# Channel Characteristics (83D.4)

Ryan Latchman, Mindspeed

Figure 83D-2— CAUI-4 chip-to-chip application

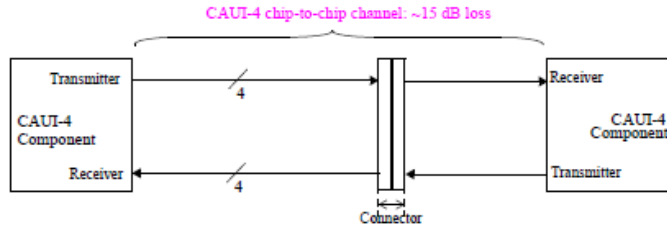
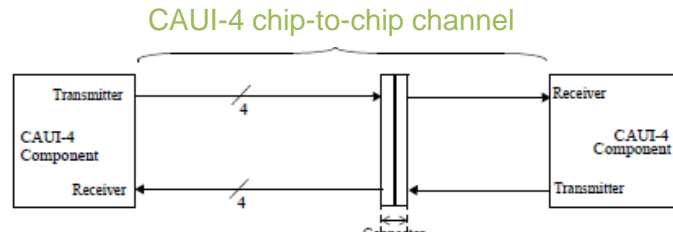
Figure 83D-2—Chip-to-chip insertion loss budget at 12.89 GHz

Figure 83D-3—CAUI-4 chip-to-chip channel insertion loss

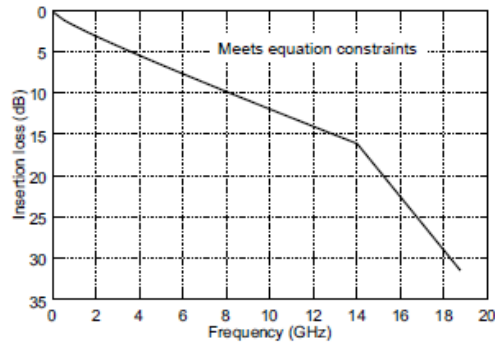
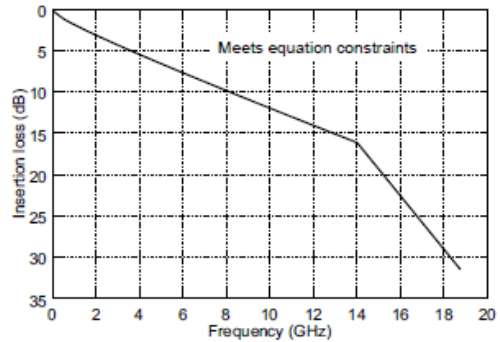
EDITORS NOTE: Insertion\_loss equation is TBC

$$Insertion\_loss(f) \leq \left\{ \begin{array}{ll} \frac{1.614(0.075 + 0.537\sqrt{f} + 0.566f)}{1.614(-18 + 2f)} & 0.01 \leq f < 14 \\ & 14 \leq f < 18.75 \end{array} \right\} \text{ (dB)} \quad (83D-1)$$

$$Insertion\_loss(f) \leq \begin{cases} 1.614(0.075 + 0.537\sqrt{f} + 0.566f) & 0.01 \leq f < 14 \\ 1.614(-18 + 2f) & 14 \leq f < 18.75 \end{cases} \quad (\text{dB}) \quad (83D-1)$$
